**ADDENDUM**

Addendum No. 1 (November 22, 2016)  
to  
Contract Documents

TOWN OF DAVIE  
**SW 48<sup>th</sup> Court Water Main**  
Town Bid No. B-17-07  
CGA Project No. 96-1630.101

**TYPICAL SECTION FOR DRIVEWAY CONNECTION**

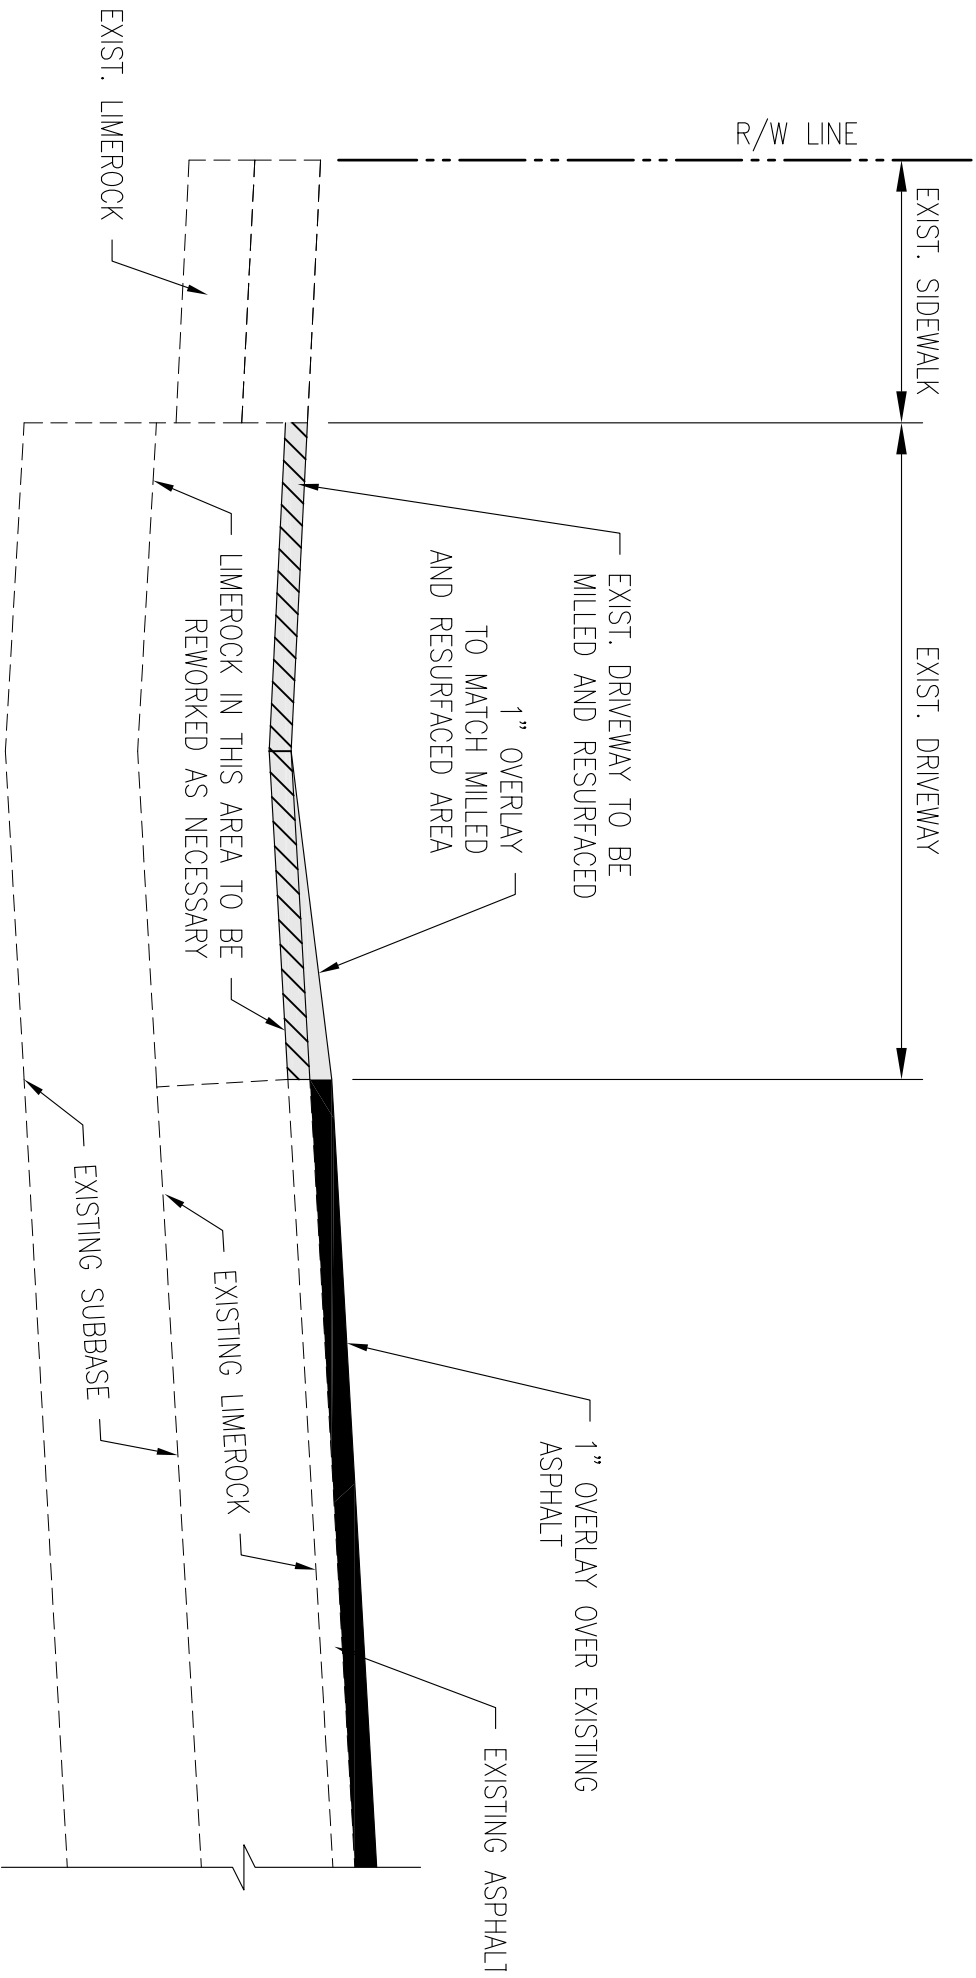
1. Being that there no milling for this project, how does the Town of Davie wants the contractor to match the lip of the driveway with the additional 1” of asphalt due to the Overlay?  
Answer: See the attached detail.
2. Being that there are no profiles in the plans (Page C2), will the Town of Davie require profiles in the Record drawings (Asbuilts)? Answer: No.
3. At +/- Sta. 13+87, during the installation of the 1” long service, it is necessary to open cut through a parking space. Is it necessary to overlay this area or will a permanent patch be sufficient? Answer: See the attached detail.
4. Will the Town of Davie consider a Directional Bore for the installation of the long services?  
Answer: No
